PERFORMANCE BULLETIN 138

K526 Valve Cap-to-Body Oring Removed

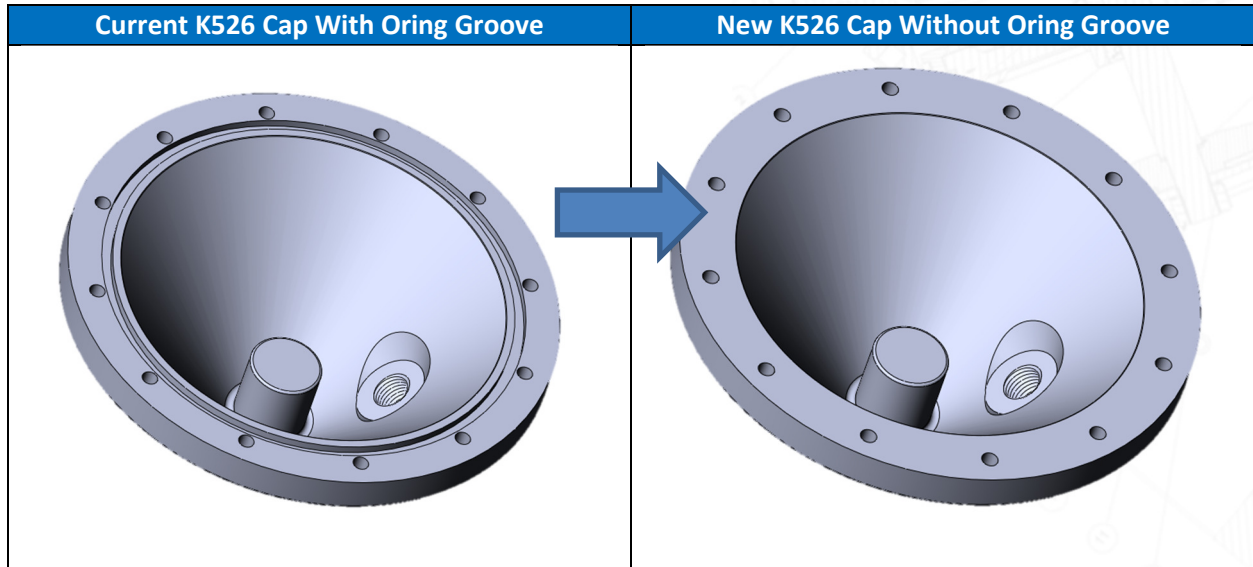
The K526 valve Cap and Body are being updated to eliminate the need for an Oring to seal against the Diaphragm. The updated Body and Cap surfaces facing the Diaphragm will now be machined to assure a flat surface which will positively seal against the Diaphragm. Previously, an Oring was required between the parts because it was difficult to maintain flatness on molded surfaces this large.

As a result of this change, Oring PN 1071713, item 9 in drawing below will no longer be required.

The Oring PN 1071713 will remain in Diaphragm and Seal Kits for the foreseeable future but will not be required if repairing valves with machined flat Cap and Body. The update will be implemented when inventory of the current version is exhausted.
